FINAL MITIGATION PLAN ADDENDUM

WYANT LANDS MITIGATION SITE PHASE II – PROJECT EXPANSION

RE: Wyant Lands Phase II Project Expansion
Lincoln County, NC
Response to NCIRT Review Comments
USACE Action ID No: SAW-2021-02449
NCDMS Project No: 100595

RE: Wyant Lands Mitigation Site Addendum
Lincoln County, NC
Catawba River Basin 03050102
Response to NCDMS Addendum Comments

Wyant Lands Mitigation Site Addendum
 Lincoln, North Carolina
 Planting List
 Planting Plan

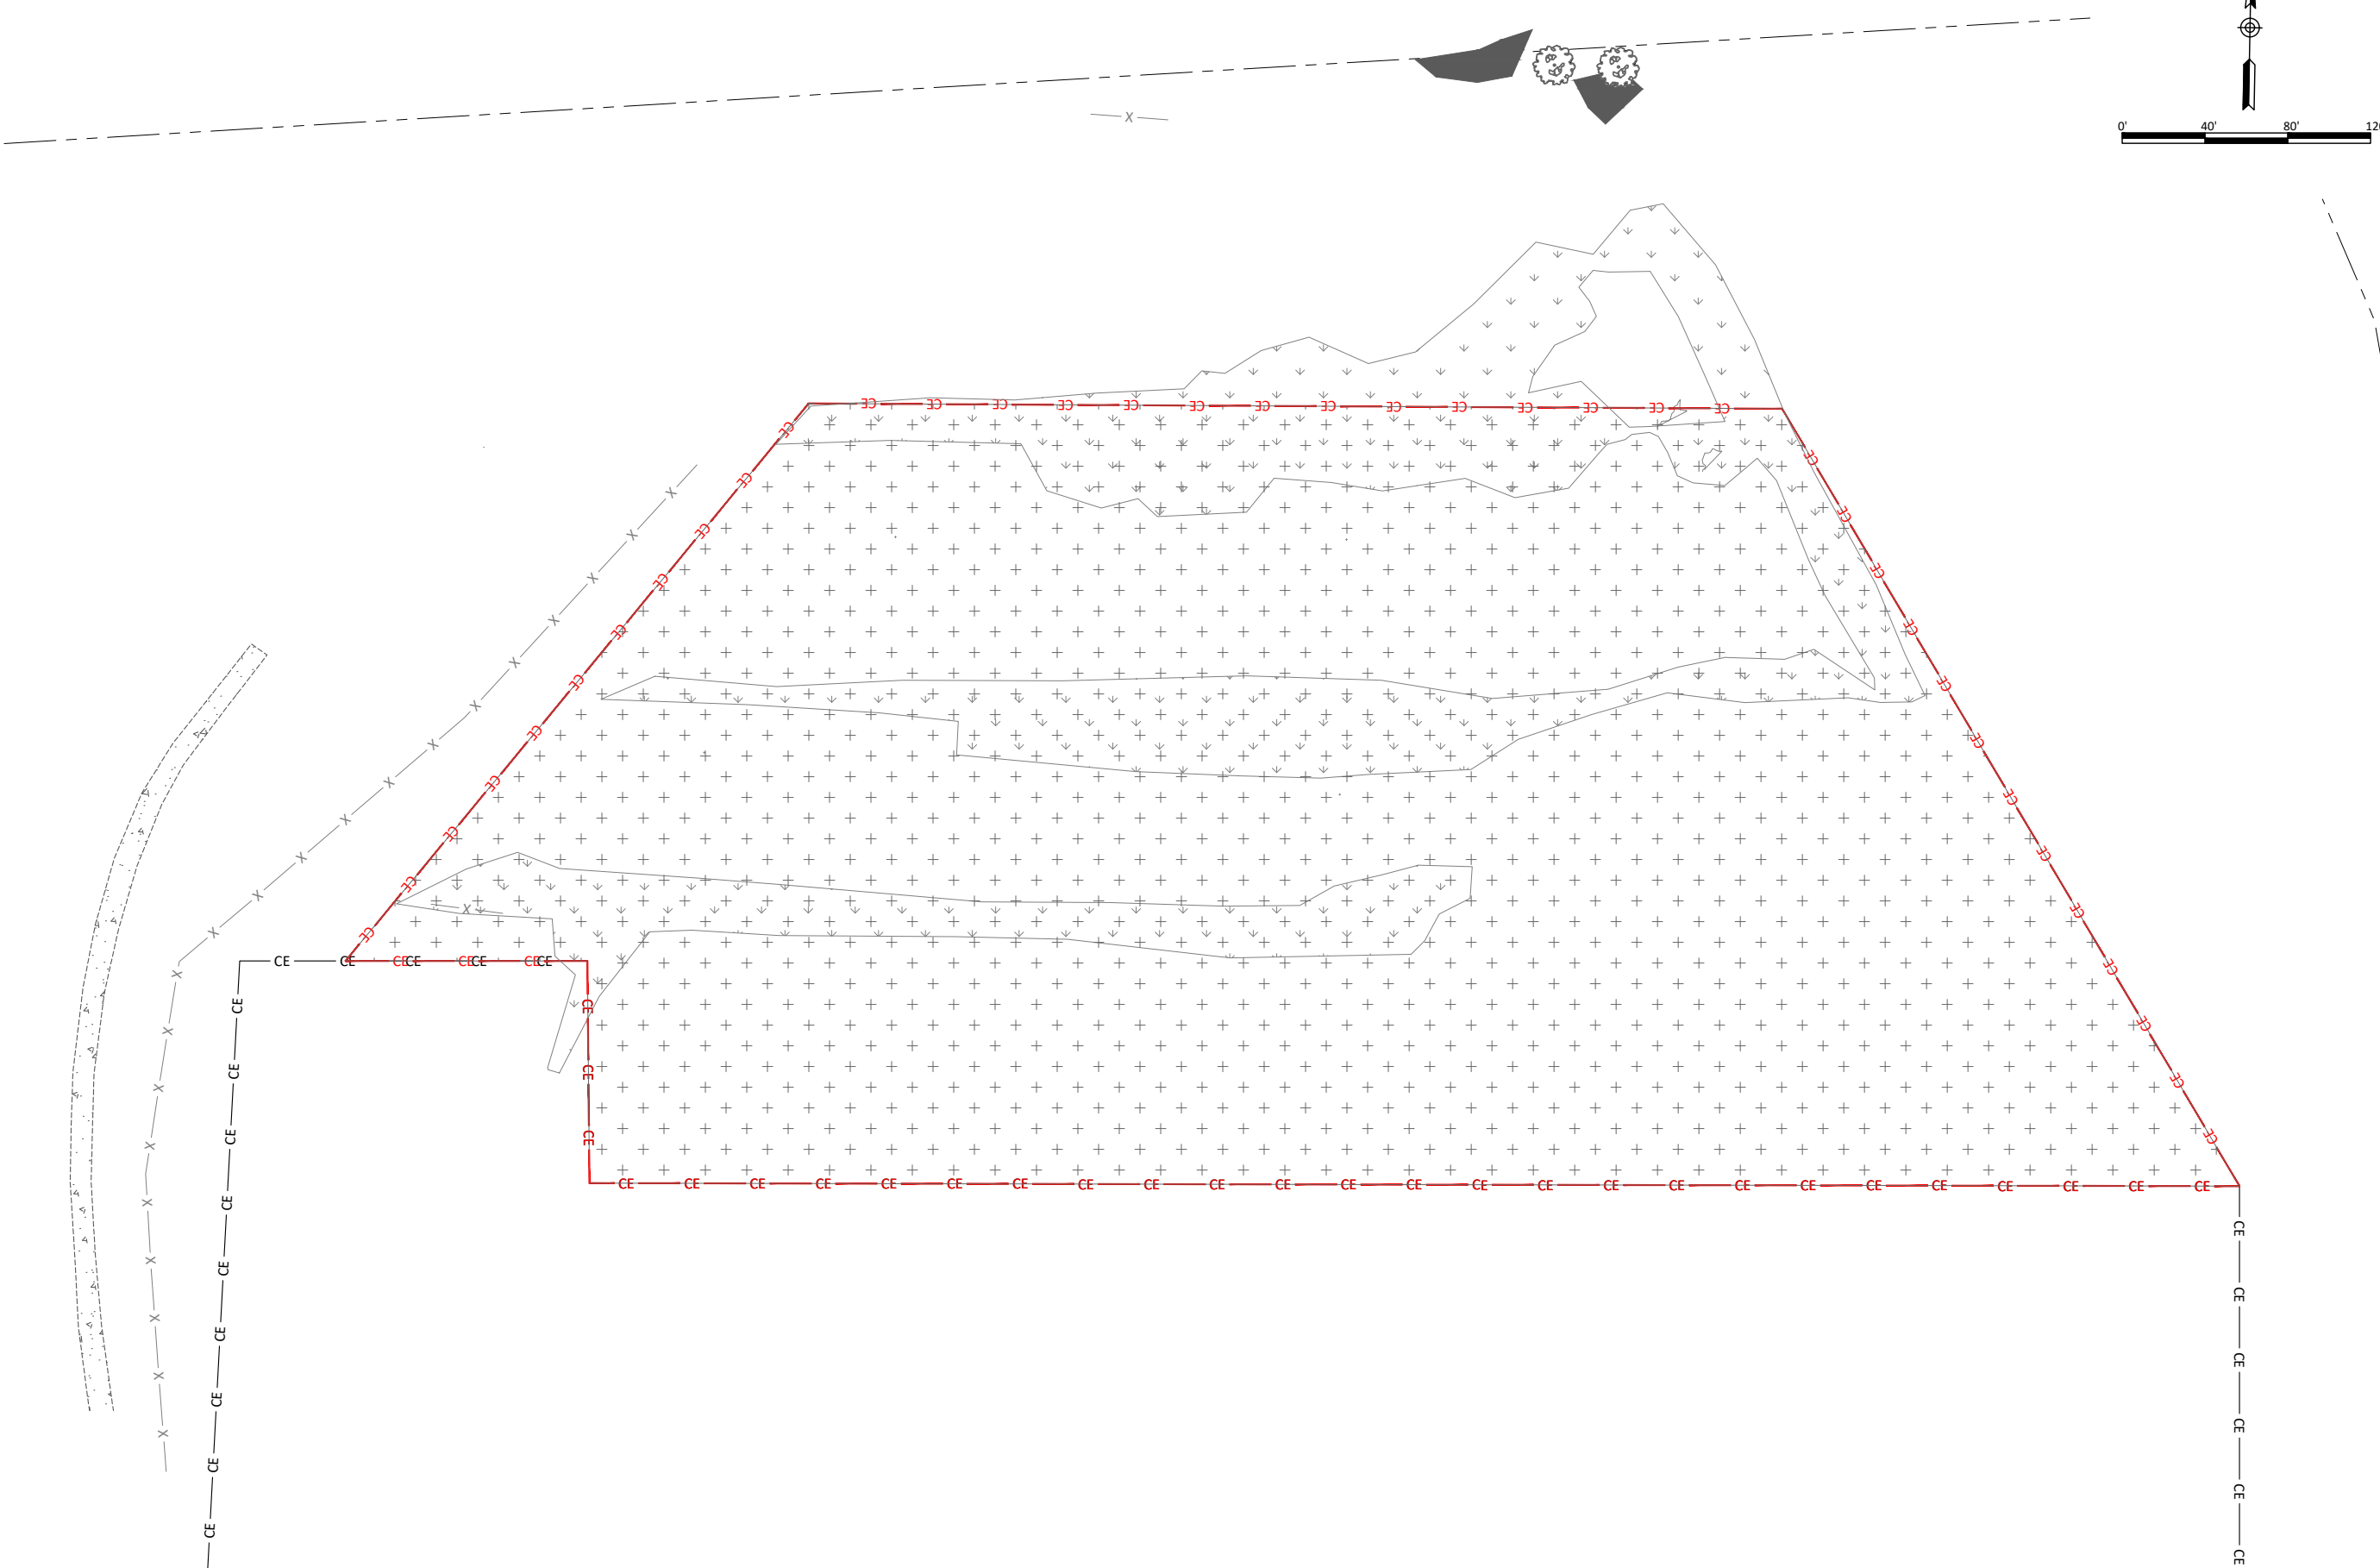
7. *Sheet 4.0 – DWR would encourage reducing sycamore and river birch percentages within the wetland planting zone in order to enhance habitat diversity.*

Wildlands Response: Wildlands has reduced the sycamore and river birch percentages within the wetland planting zones. Willow oak, swamp chestnut oak, common button bush, and swamp rose percentages were all increased.
